*Previous
Approval for Lake Confer*

Minutes
TOWN OF BLUE RIVER
PLANNING AND ZONING COMMISSION REGULAR MEETING
June 7, 2022
0110 Whispering Pines, Blue River, CO 80424

TO: Michelle Eddy, CMC/CPM - Town Manager/Clerk
FROM: Thomas Marshall, Plan Reviewer - CAA
DATE: May 31, 2022
RE: Planning/Zoning/Architectural Guidelines review –
0066 Conifer Drive

EXTERIOR ELEVATIONS

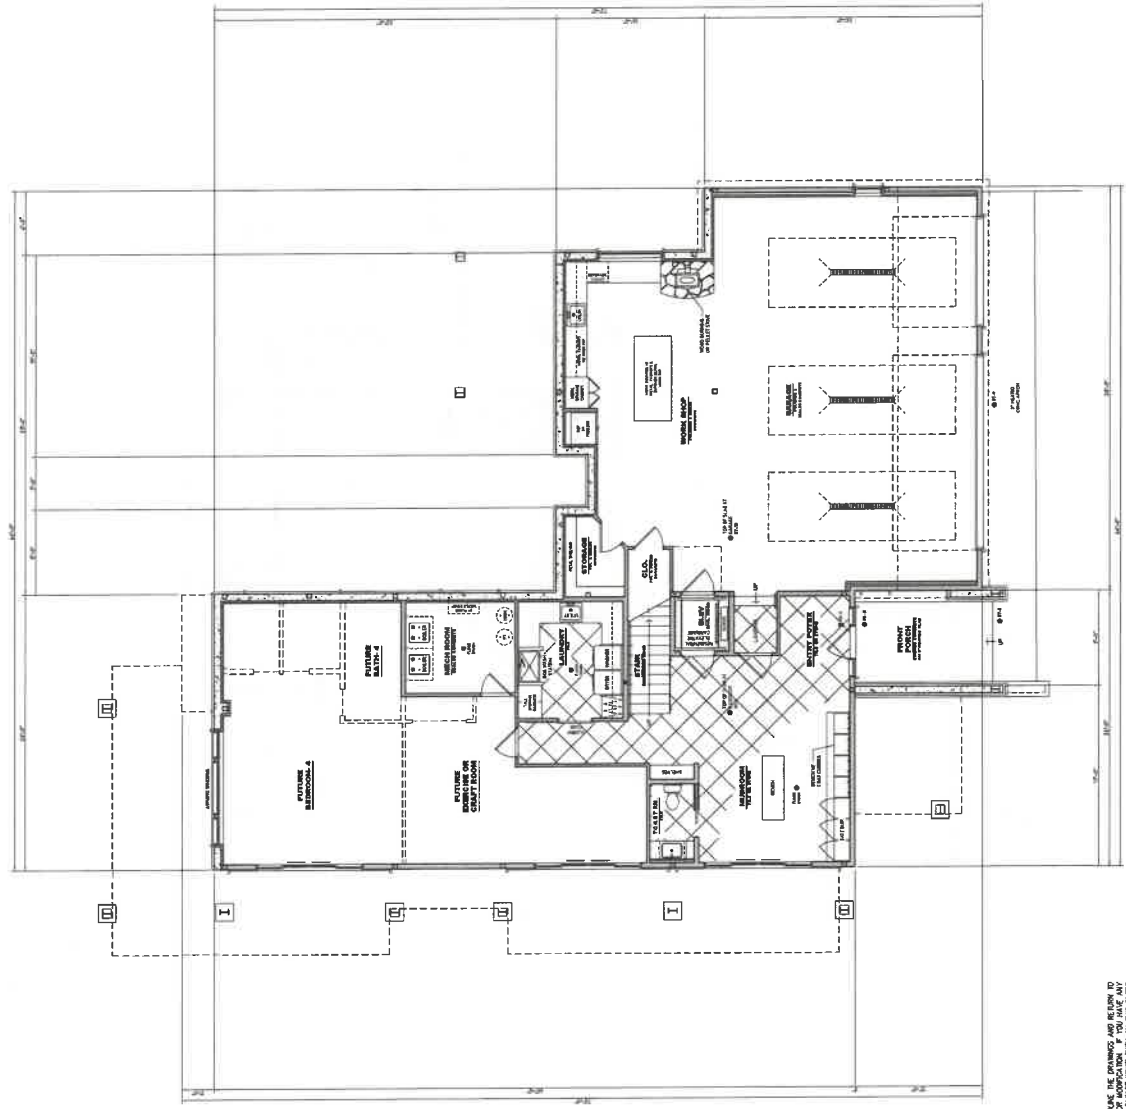
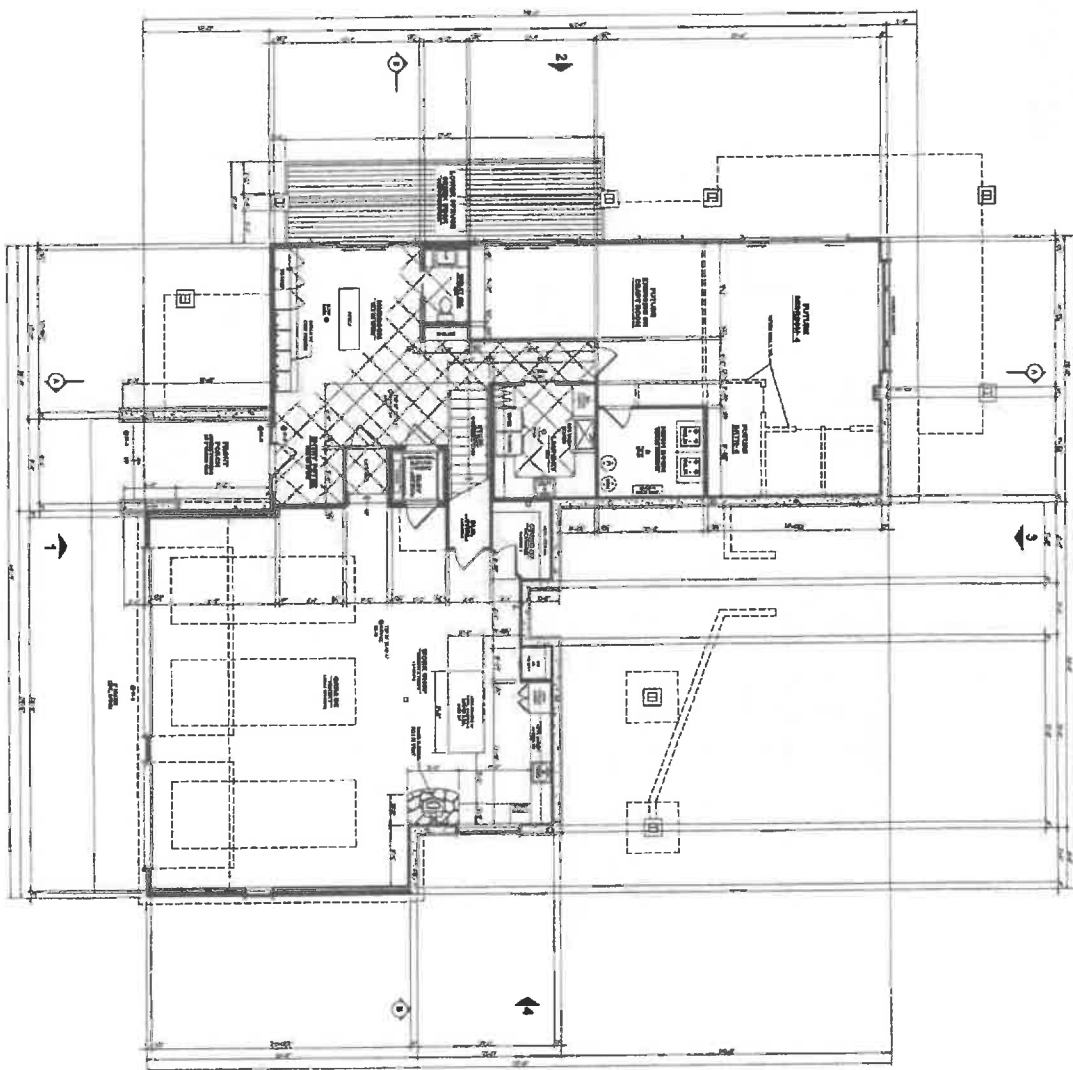
VII. B. Building Forms	Proposed foundation walls merge with the existing grade, vertical walls appear in general compliance. Deck column bases are board formed concrete in a non-specific color.	
VII. C. Setbacks	The proposed structure sits within the required setbacks per the submitted site plan.	Y
VII. D. Building Height	Building height complies with requirements. The new roof height is a proposed 32.4' and shall not exceed 35'.	Y
VII. E. Roofs	Primary and secondary roof slopes are proposed with a 2:12 slope which is inconsistent with the towns stated preference for slopes between 4:12 – 10:12. Town approval is required. The plans identify the roof covering as silver metal. Metal roofs are allowed in muted, non-reflective earth tones or dark natural colors.	N
VII. F. Exterior Wall Materials	Exterior materials are a combination of cultured stone in a non-specified light tan or off-white color, horizontal composite siding, and composite board and batten are proposed in a non-specific gray blue color. A more specific color board should be provided

VII. G. Exterior Trim	Exposed painted steel beams are indicated but a color is not specified. A non-specified light-colored wood-stained soffit with wood and metal fascia are proposed. A more specific color board and colored rendering is necessary.	
VII. H. Windows and Doors	The garage door color and material is not specified. The front door is proposed to be black or dark brown. Windows are proposed aluminum clad. A more specific color board and colored rendering is necessary.	
VII. I. Balconies and Railings	A manufactured cable railing system with a wooden top rail is proposed. Town approval is required for the long expanses of repetitive balconies and railings.	
VII. J. Chimneys and Roof Vents	Chimneys extend above the roof line with a cultured stone veneer and capped with a metal cap and spark arrestor. The metal cap color is not identified, but per

Town regulations is required to match the approved roof color.	
VII. K. Exterior Colors	The color photograph of a similar but smaller home and the materials sheet requires more specificity. A more specific color board and colored rendering is necessary.	
VII. L. Solid Waste Collection and Service Areas	None identified but shall be field verified during construction.	
SITE ELEMENTS		
VIII. A. Retaining Walls, Landscape Walls, Fences, and Screening	New boulder retaining walls, require Town approval due to their proposed construction outside the setback. Additional discussion should be given to the visual mass of the boulder retaining walls as viewed from neighboring properties and seek a possible vegetative screening. Please notate the required screening of metering equipment from neighbor's view on the required landscape plans referenced in Item B below.	
VIII. B. Terraces, Patios, Walkways and Decks	New composition decks and stained concrete patios are proposed.	Y

Site and Grading Plan

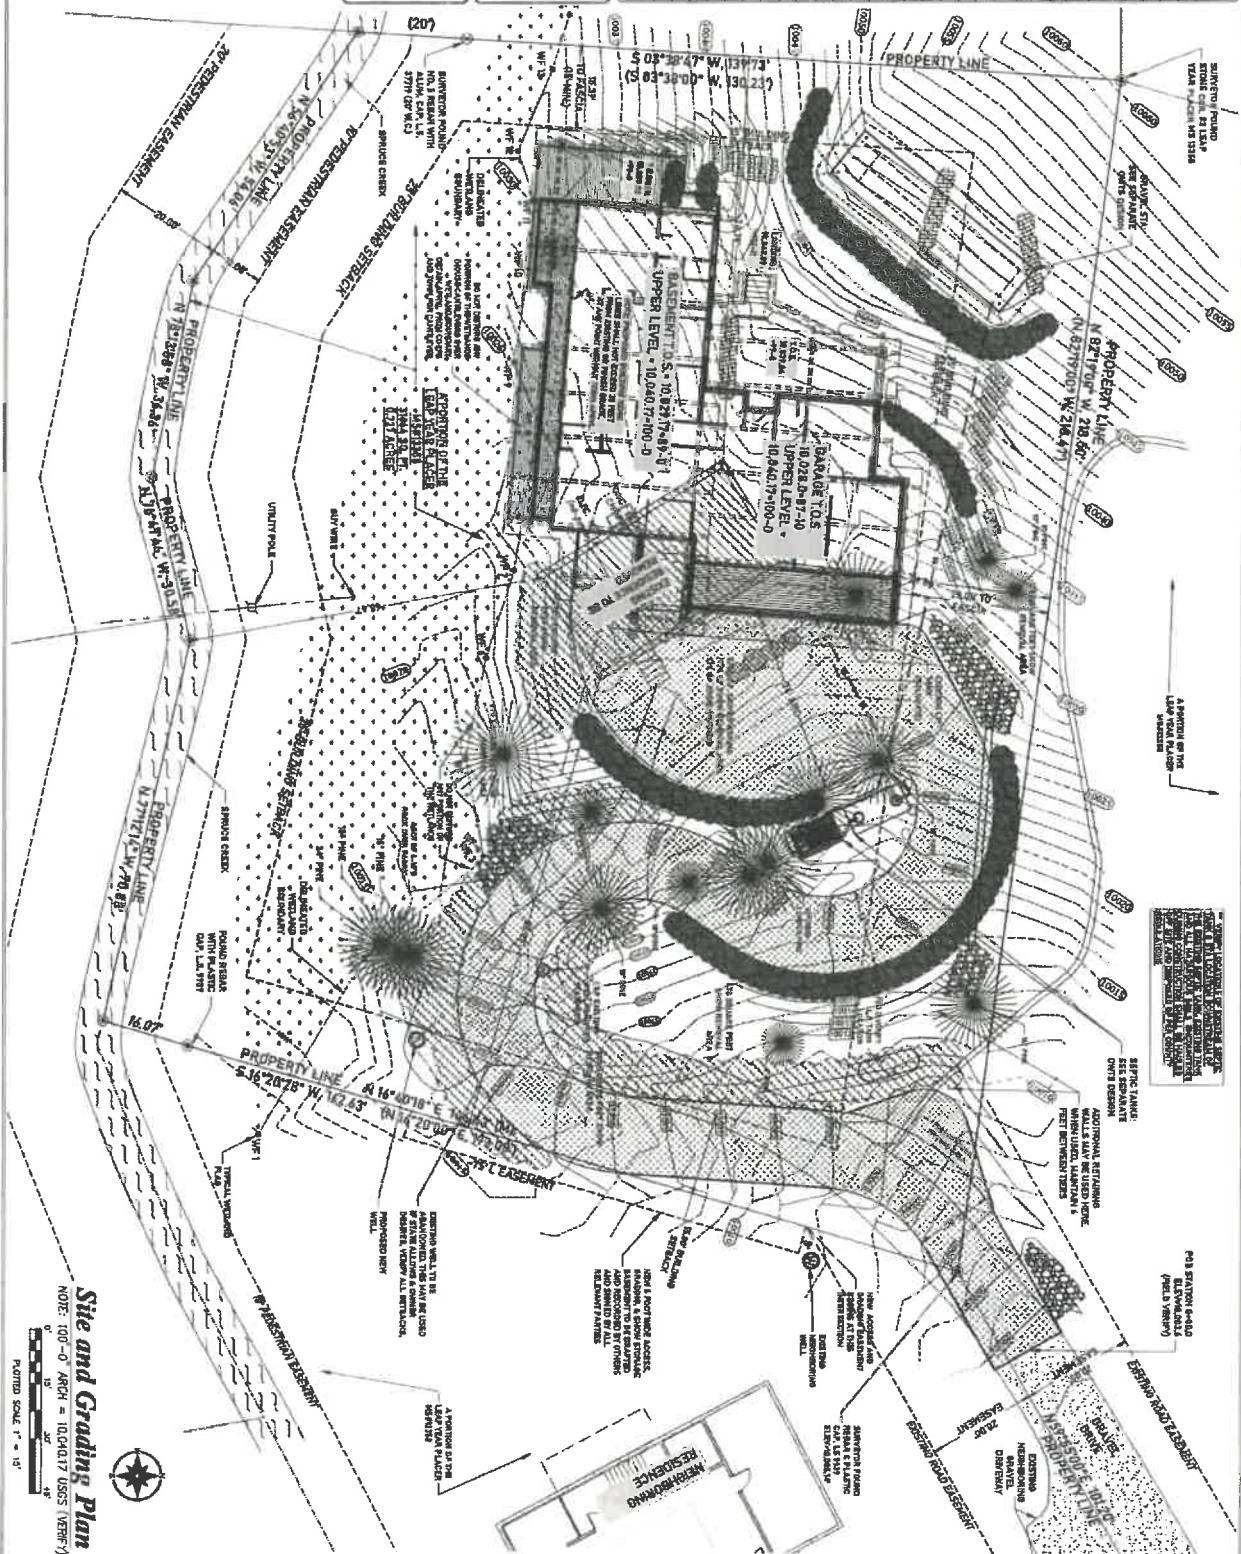
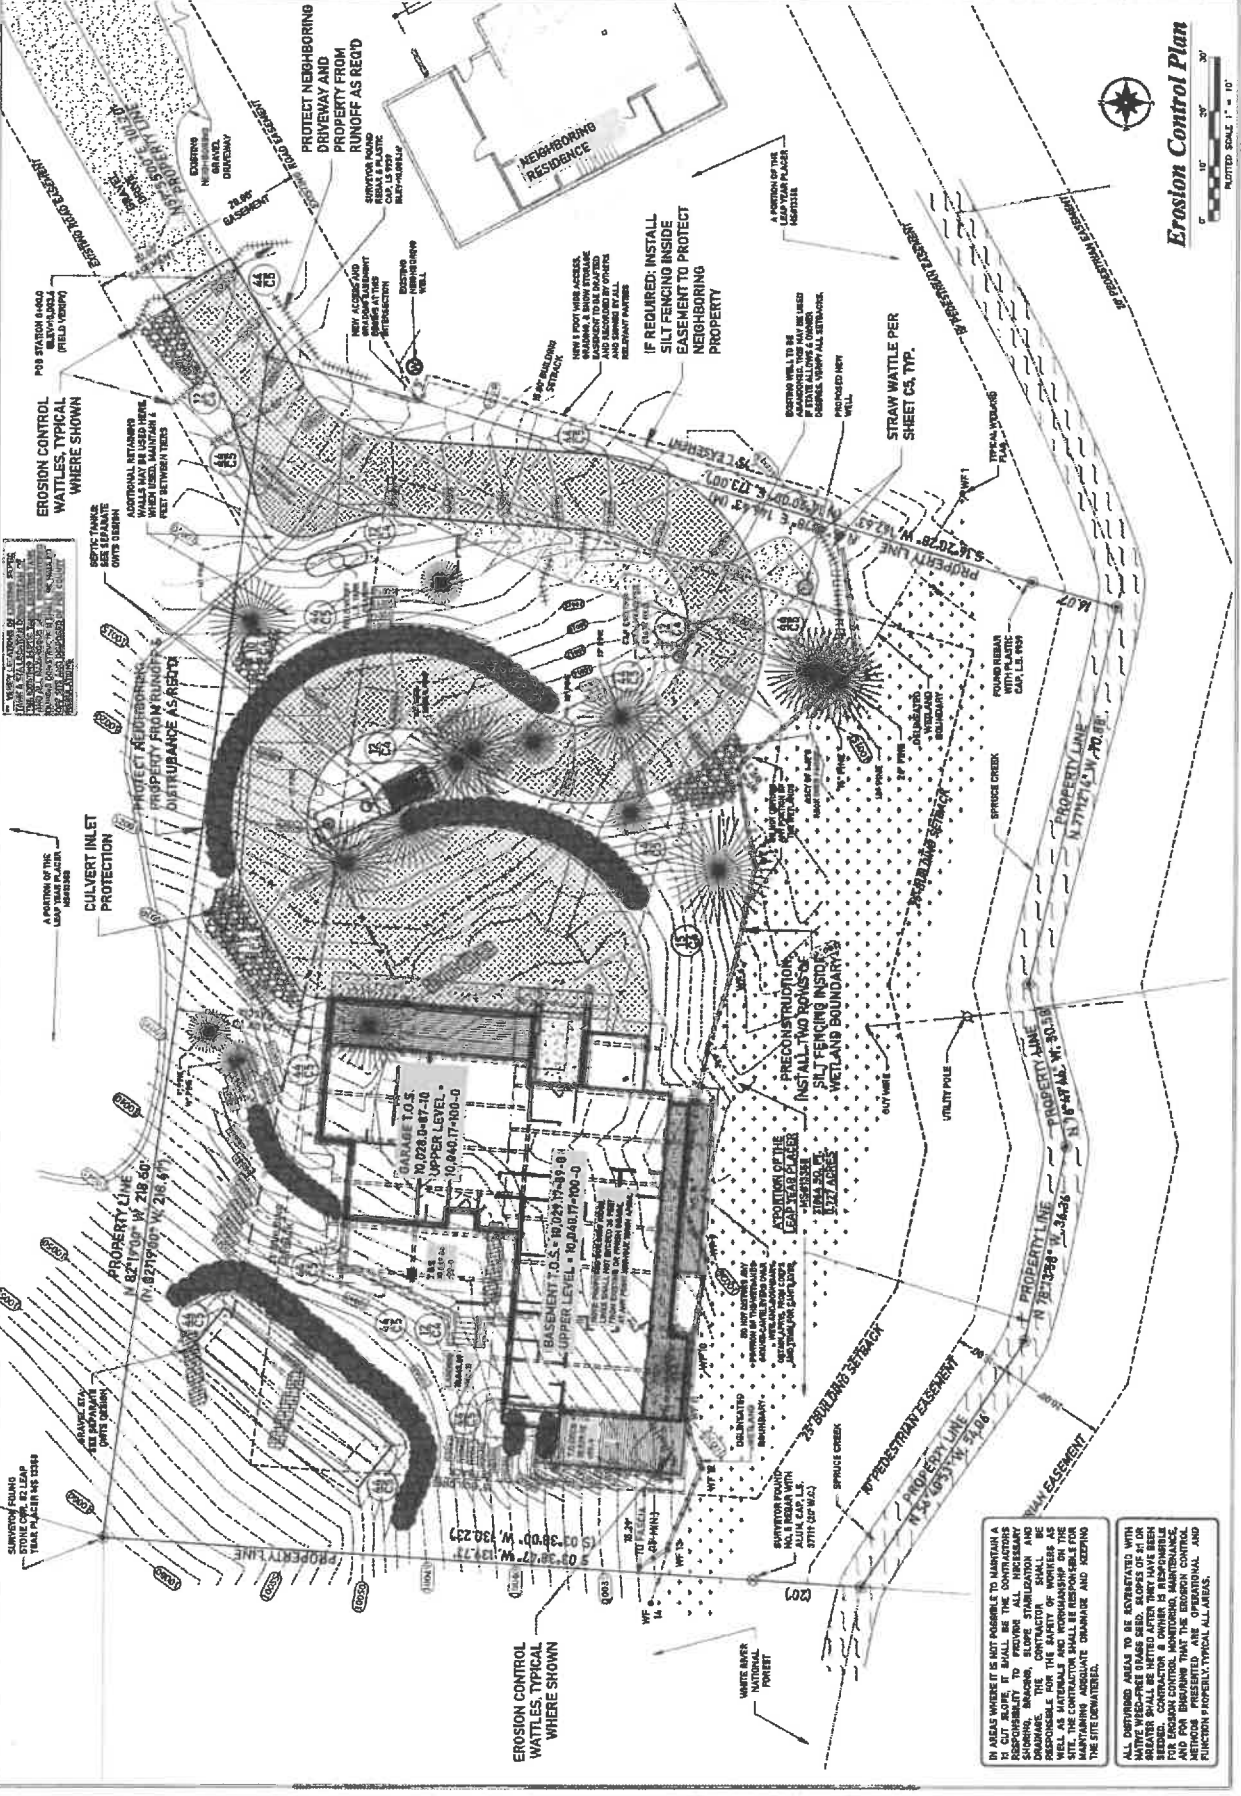
STANDARD	NOTES/REMARKS	SUBSTANTIAL COMPLIANCE
DEVELOPMENT STANDARD		
VI. B. Building Envelope	The proposed home is properly sited within required setbacks. The submitted site plan also depicts several proposed boulder walls which require Town approval due to their location outside the building envelope. A proposed 5' wide easement will be sought to provide for grading, snow storage and a portion of the driveway along the Eastern boundary.	
VI. C. Building Siting	The proposed location and siting of the home takes into consideration the natural landforms and topography of the site.	Y
VI. D. Grading and Drainage	Cut and fill slopes are proposed to be kept to a minimum and final grading should avoid unnaturally broad, flat surfaces. The trees and vegetation which are to be removed to accommodate the new driveway are not adequately identified. Additional discussion should be given to the visual mass of the boulder retaining walls and seek clarification of proposed vegetative screening. Two large curves of boulder retaining walls have been proposed to support the

serpentine driveway and mitigate the flow of water across neighboring properties to the East and North.	
VI. E. Driveways	The existing gravel driveway is to be removed. A new 14' wide, 5780 s.f. serpentine gravel driveway is proposed and subject to Town approval due to the large area of disturbance. Adequate snow storage area has been calculated and shown on the site plan. The maximum width allowed for driveways is 12'	N
VI. F. Parking / Garages	The proposed 3 vehicle garage and exterior parking meet the requirement.	Y
VI. G. Exterior Equipment and Satellite Dishes	Exterior equipment and metering devices are identified.	Y
VI. H. Easements and Utilities	A pedestrian and existing road easement are identified. A proposed easement is noted for the Eastern property line. Documentation was not included with this submittal.	N
VI. I. Recreation Facilities	A gas fire pedestal is proposed on the rear concrete patio.	Y
